# Certificate of Appropriateness

2742 W. STATE ST., **Concordia Historic District, City Of Milwaukee, owner**

PTS ID 73475 COA, exterior repairs

Porch hood bracket for rear door

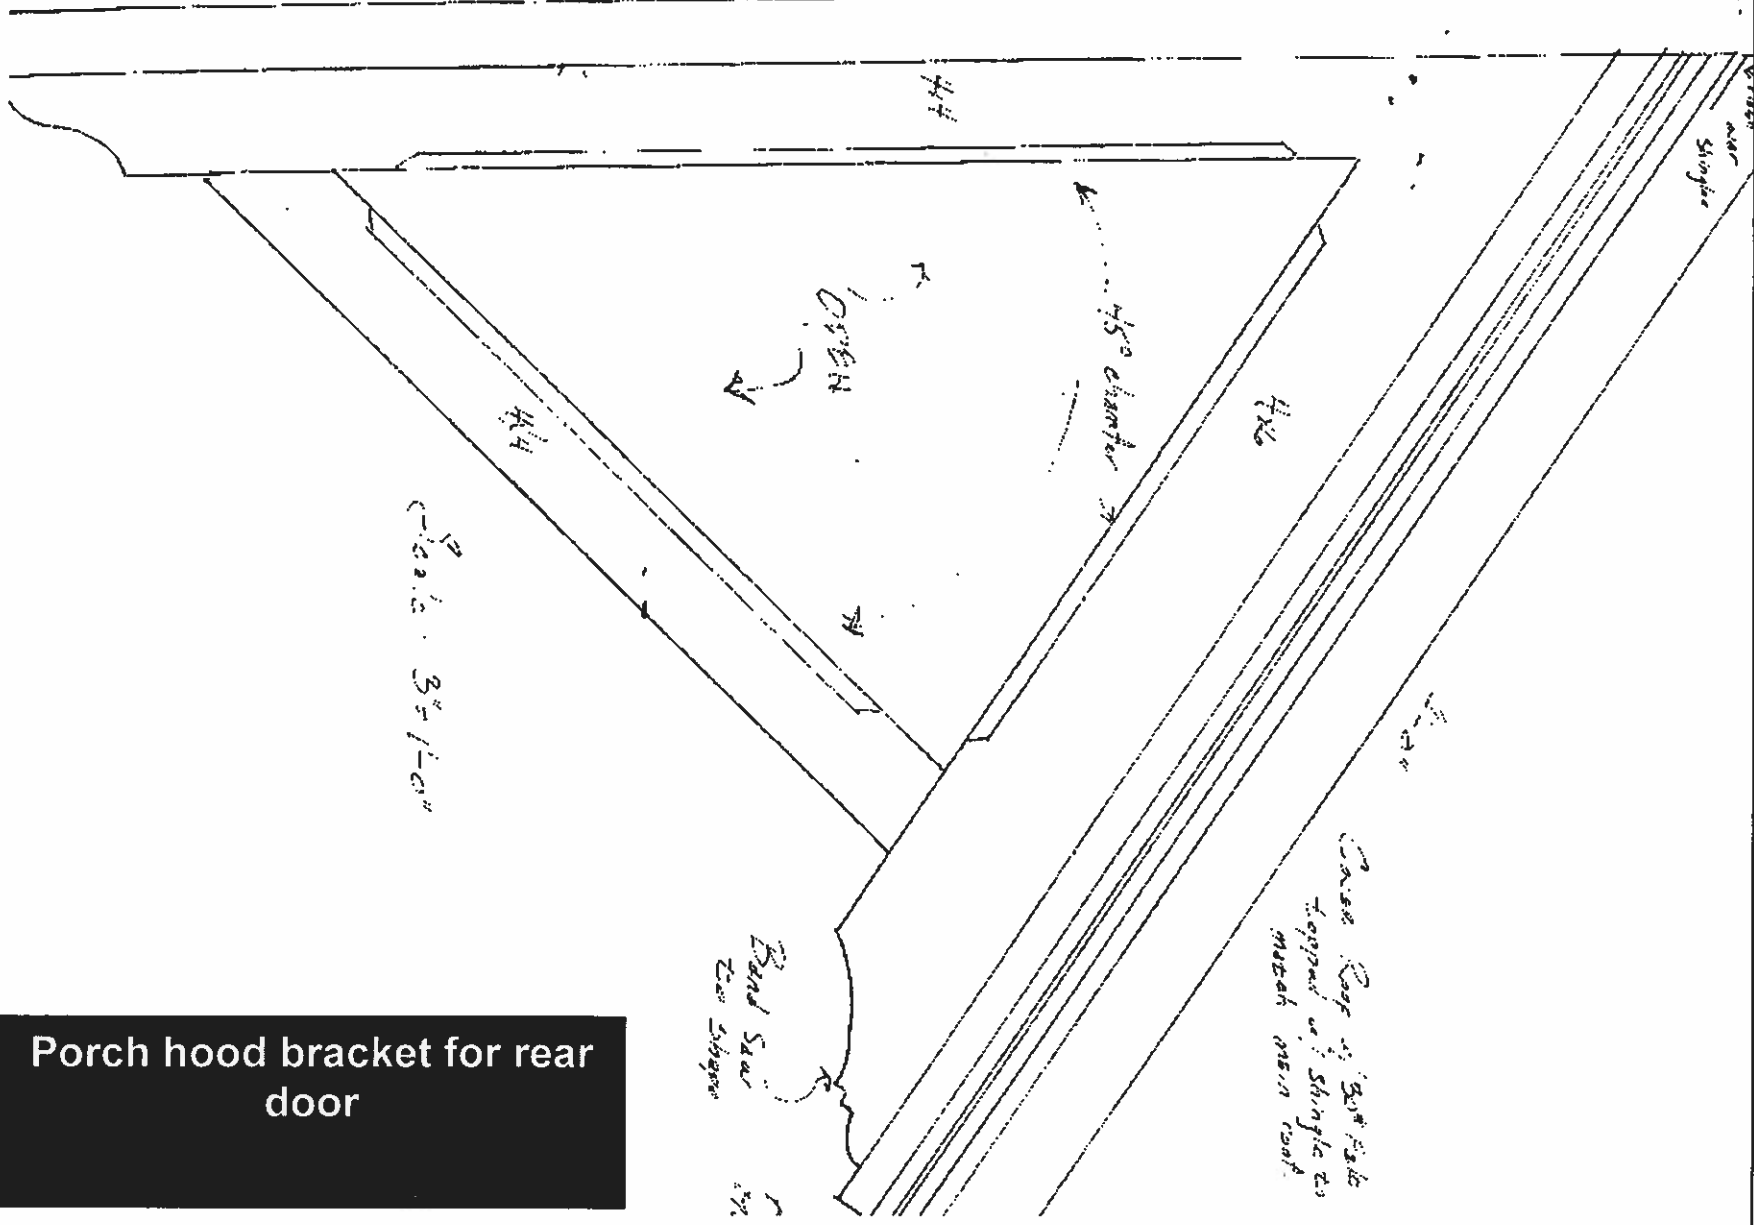
Design for ladder-style new rear door to replace the one that was destroyed by the fire.
